# 16 ZON2009-01097

#### PLANNED UNIT DEVELOPMENT

**DEVELOPMENT NAME** SME Airport, LLC

<u>CONTEMPLATED USE</u> Planned Unit Development Approval to allow a truck unloading and trash pickup service yard in an existing parking lot in a B-2, Neighborhood Business District.

## SITE PLAN

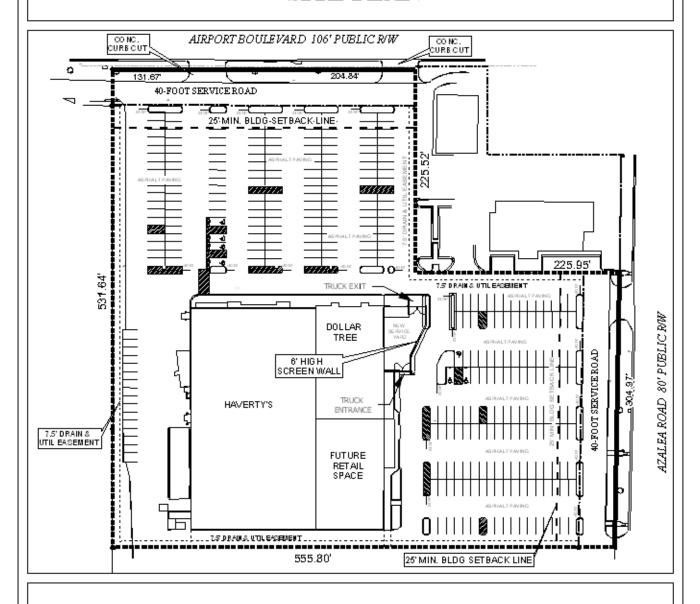
The site plan illustrates the 53,048 square foot retail building with the proposed service yard (completely screened from view) on the Northeast corner of the structure. The applicant states that the use of the service yard will include truck unloading and trash pick up. While several parking spaces will be removed for the addition, the applicant will retain 306 parking spaces (only 177 are required).

As illustrated on the site plan, trucks will enter the service area from the South and exit to the North. This raises two concerns. First, staff is concerned about visibility, as it may be difficult for trucks to anticipate traffic circulation outside of the service area; its location will yield a rather awkward traffic flow (see site plan). Second, the proposed site plan does not appear to be pedestrian friendly, as no sidewalk is illustrated around the service area to access other retail establishments. This will require customers to either walk into traffic aisles, or they will have to drive, which defeats the purpose of an outdoor strip mall.

It should be noted that, currently, there is minimal landscaping and trees on site. Several curbed "islands" exist throughout the parking area that could be landscaped. Particular in parking lots of this size (over 300 spaces), landscaping aids in breaking up the expanse of paving and provides valuable shade for pedestrians and/or vehicles. At a minimum, staff recommends that the applicant landscape all "islands" in the parking lot with grass and understory trees.

Based on the preceding, it is recommended that this application be held over until the June 4<sup>th</sup> meeting to allow the applicant to address the following:

1) provision of a sidewalk around the service area;

2) provision of landscaping and understory trees throughout the parking lot, specifically on the existing curbed islands;

- 3) compliance with City Engineering comments: (Must comply with all storm water and flood control ordinances. Any work performed in the right of way will require a right of way permit. Drainage from trash loading/unloading areas cannot discharge to storm sewer; must have connection to sanitary sewer);
- 4) compliance with Traffic Engineering comments: (*Driveway number, size, location, and design to be approved by Traffic Engineering and conform to AASHTO standards. Wall height and planting should be chosen that do not block line of sight for traffic stopped next to the service area*); and
- 5) full compliance with all municipal codes and ordinances.
